# Highways Assessment

Dover Road, Walmer, Kent

Iceni Projects Limited on  
behalf of Gladman  
Developments  
June 2017

## 2. RESPONSE TO 26<sup>TH</sup> MAY 2017 HIGHWAY COMMENTS

Plate 2: Stopping distance comparison looking to the south

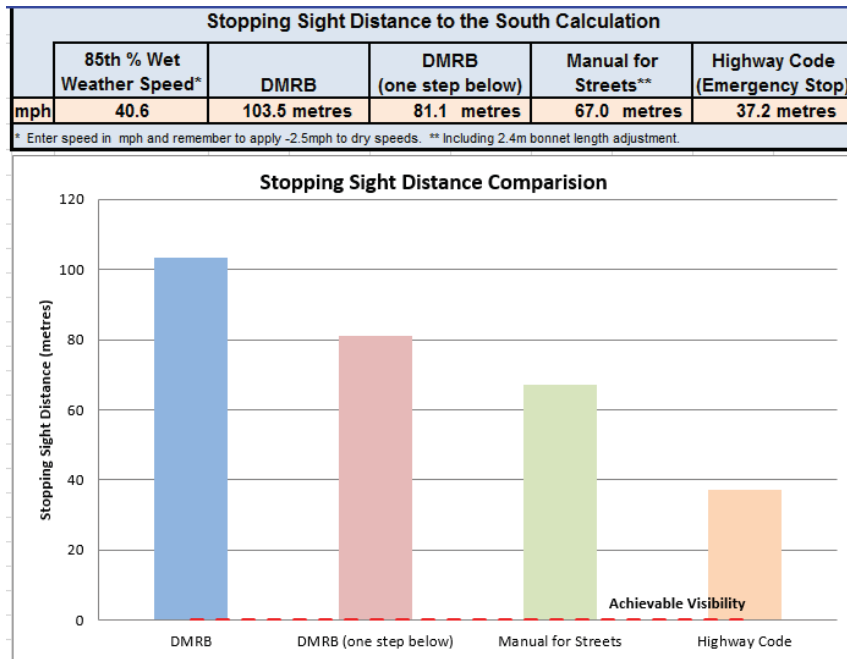
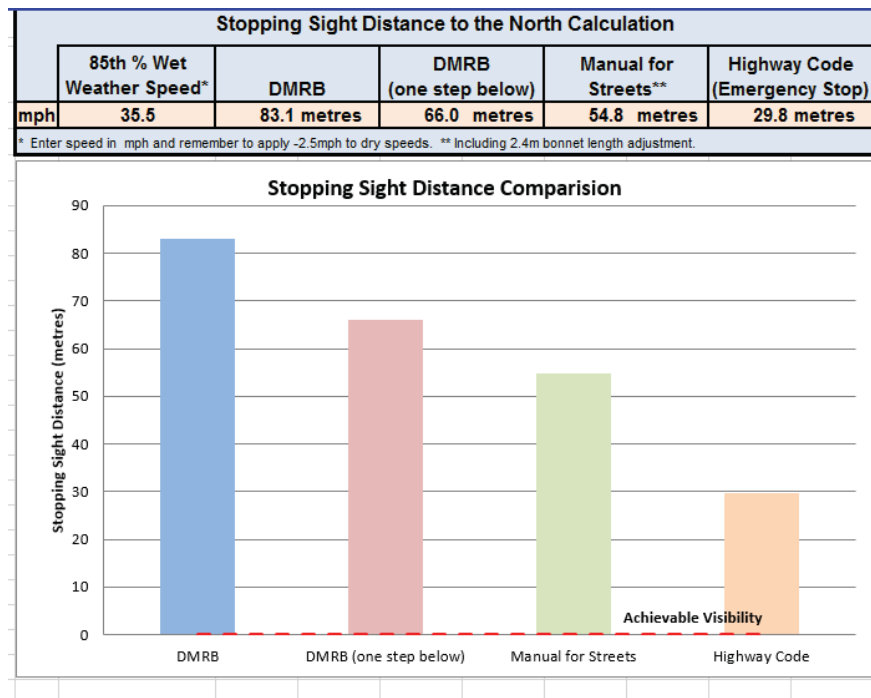
*Visibility splays have not been previously agreed as suggested. Whilst a reduction has been made for wet weather speeds there is no indication of the weather during the speed survey to ascertain if this reduction is appropriate. Manual for Streets 2 identifies that for measured speeds over 60 kph (37 mph) more onerous values for reaction time and deceleration rate should be used, as well as account being taken of the gradient of the road, and this would potentially increase the visibility required. The visibility calculations should therefore be reassessed and appropriate splays provided accordingly*

- 2.1 The “Desirable Minimum” Stopping Sight Distances (SSDs), 215m for 60mph and 90m for 30mph, in the *DMRB* are based on a driver perception/reaction time of 2 seconds and a deceleration rate of 0.25g. The “Absolute Minimum” (now known as One Step Below Desirable Minimum) SSD values use the same reaction time of 2 seconds and a deceleration rate of 0.375g. The *MfS1* and *Manual for Streets 2: Wider Application of the Principles (MfS2, CIHT, 2010)* both advocate the use of a lower driver reaction time of 1.5 seconds in areas where vehicle speeds are up to around 40mph. Taking this into account and due to our wet weather speeds being around the 40mph mark we have used the *MfS1* and *Manual for Streets 2* lower reaction times.

- 2.2 Adopting the above parameters results in the following SSDs for the 85<sup>th</sup> percentile wet weather speeds. Wet weather speeds are derived in accordance with *DMRB TA22/81* which suggests a deduction of 2.5mph (4kph) for single carriageway roads.

- 2.3 Stopping site comparisons for both north and southbound are shown overleaf at **plates 2 and 3**.

2.4 Both visibility splays looking left and right at the proposed accesses are contained within the site boundary and adopted highway land, revised layout of the site access is available at **Appendix A2**.
